Our Ref: 24298/P
Doc Name: L-Submission C244melt VPA March 2025
njh

Amendment C244melt – Melton East PSP
Submission for [REDACTED] re 780-792 & 794-834 Leakes Road Grangefields

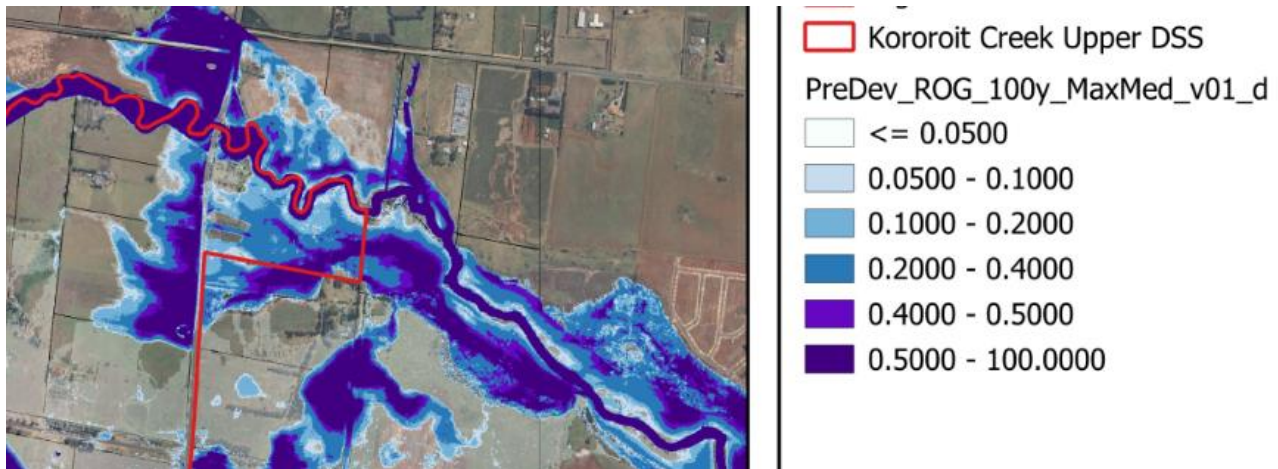
The draft Kororoit Creek Upper Drainage Scheme, released by Melbourne Water, provides the following map (prepared by Alluvium) which suggests that pre-development conditions will see part of our client's sites impacted by floodwater for the 1% AEP Event.

We request a copy of the professional report that proves that this is correct.

This plan is quite critical to the designations that have been applied to my client's land. It is quite clear that the majority of the land is capable of being developed for urban purposes and that the PSP should be amended to reflect a development potential of at least half if not three-quarters of the site.

The draft DSS suggests that a retarding basin will be located just to the south of the southern boundary of our client's land. This is inconsistent with the PSP which suggests that a drainage reserve will be located in the eastern portion of our client's land.

We seek clarification as to which is correct.
